**ADDENDUM NO. 1  
TO THE  
BIDDING REQUIREMENTS AND CONTRACT DOCUMENTS  
FOR THE  
I-64 BLACK RIVER REST STOP GRINDER PUMP CONNECTIONS**

**OWNER:** Posey County Regional Sewer District  
P.O. Box 88  
Mount Vernon, IN 47620

**ISSUED BY/ENGINEER:** Egis BLN USA, Inc.  
8320 Craig Street  
Indianapolis, Indiana 46250

**ISSUE DATE:** June 19<sup>th</sup>, 2026

**I-64 Rest Stop Grinder Connection**  
 9808 New Harmony Rd., Poseyville, IN 47633  
 Posey County Regional Sewer District  
**Apostolic Bible Church**

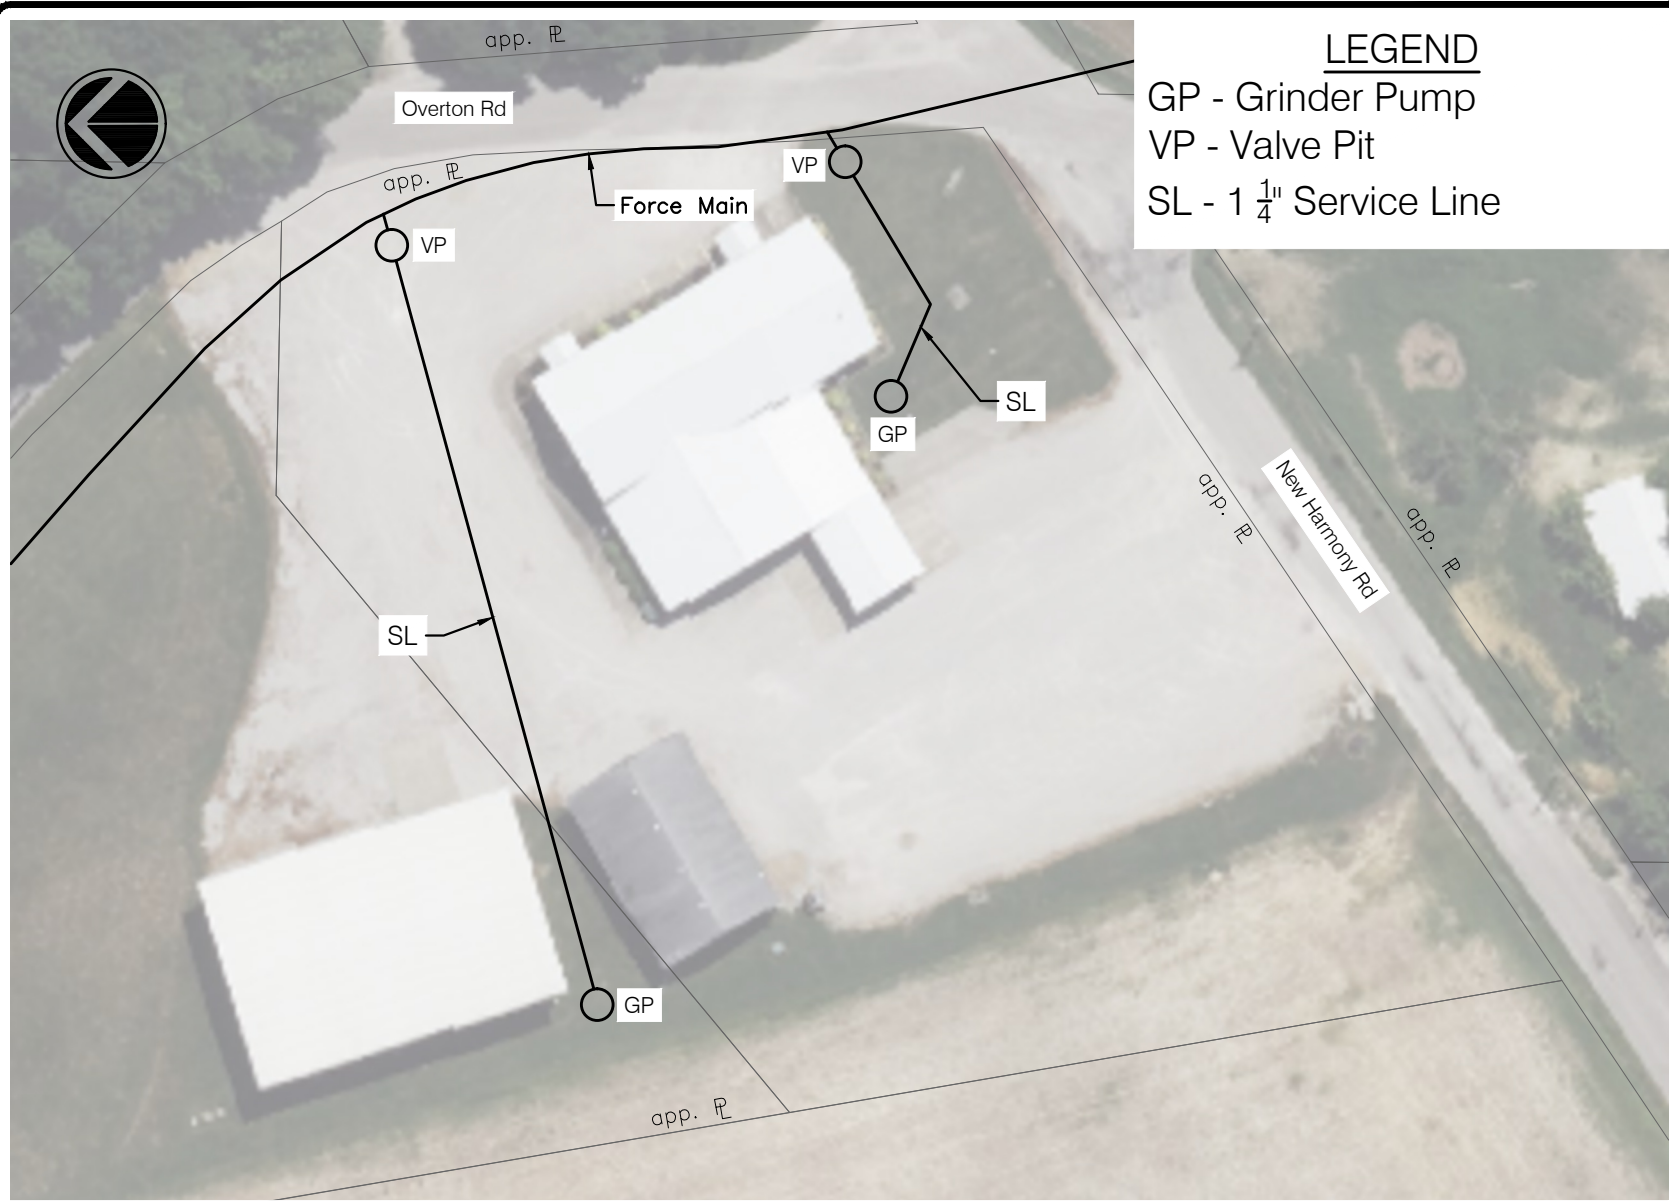
- B. The Legend & Notes sections on the drawings in Section 00315 have been updated to show the service lines as 1.25”.
- C. The Notes section on the drawings in Section 00315 have been updated to the correct lengths of pipe for each installation method.

- D. A note was added to the Sheet 1 detail stating: "Connection to the existing force main shall be done with an electrofusion tapping tee suitable to tap a force main under a live connection. This tee shall be a Elofit Tapping Tee with Belt SDR 11 or approved equal."
- E. The Sheet 1 detail was updated to callout that the 6" lateral as SDR26 PVC.
- F. The note on the Sheet 1 detail for the connection to the existing home lateral was updated to callout a connection with a Hymax coupling.
- G. The Overton & Hoehn drawings in Section 00315 have been updated to shift the valve pit onto the homeowner side of the road.

**LEGEND**  
 GP - Grinder Pump  
 VP - Valve Pit  
 SL - 1 1/4" Service Line

1. THE LOCATIONS OF THE GRINDER STATIONS, SERVICE LINES AND SERVICE VALVE VAULTS WERE DETERMINED BASED ON INITIAL SITE VISITS AND DISCUSSIONS WITH THE PROPERTY OWNER. IT IS THE CONTRACTOR'S RESPONSIBILITY TO MEET WITH THE INDIVIDUAL PROPERTY OWNER PRIOR TO INSTALLATION AND AFTER 811 LOCATES ARE CALLED IN TO DETERMINE THE FINAL LOCATION OF THESE NEW FACILITIES. ADJUSTMENTS MIGHT HAVE TO BE MADE DUE TO EXISTING UTILITIES. REVISIONS THAT REQUIRE SUBSTANTIAL CHANGE IN COST SHALL BE APPROVED BY THE OWNER BEFORE INSTALLATION.
2. THESE INSTALLATIONS WILL INCLUDE 170 FEET OF 1.25" HDPE SDR-11 SERVICE BY OPEN CUT AND 185 FEET BY UNCASSED DIRECTIONAL BORE.
